## file note

**Subject:** River Tib  
**Project:** Rylands Building - Manchester  
**Reference:** RBM-WHL-XX-XX-FN-S-0052\_P01  
**Author:** EAJC  
**Reviewer:** NGRC

Figure 5.2: River Tib Hilton Street Intersection

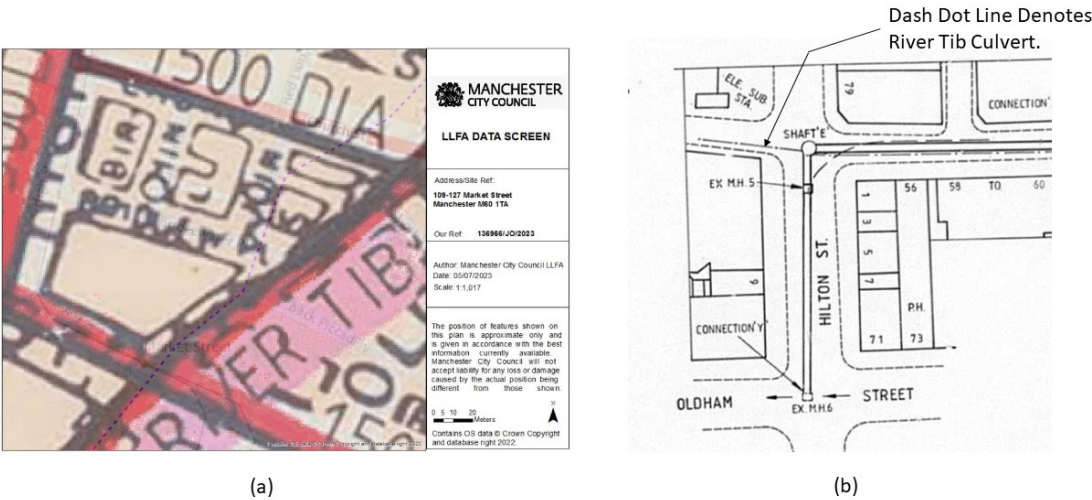
Crucially, the culvert appears to be tight to the southern kerb of the intersection between Tib Street and Hilton Street, this conflicts with the Lead Local Flood Authority (LLFA) drawings which show the alignment of the river being out of Tib Street by this intersection.

The difference in paths of the River Tib is more clearly illustrated on the extract from the LLFA drawing over the city street map. This shows that the line of the River Tib runs parallel with Tib Street at a location where the 1985 record drawings clearly show the River being culverted along the length of Tib Street, see below.

| <b>TIB ST. SEWER REPLACEMENT</b>                                  |                                           |      |

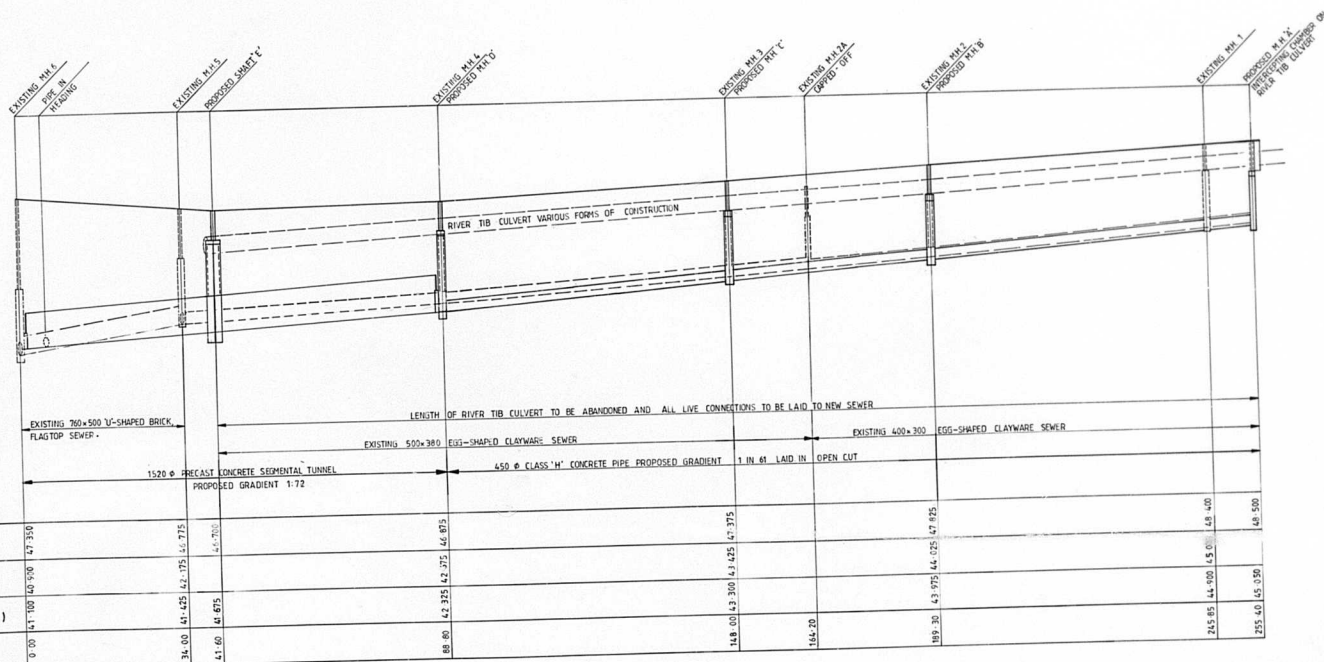
The record drawing contained within Appendix A Figure 3.1 shows the sewer replacement along Tib Street which also includes a dot-dash line for the 'Existing River Tib Culvert'.
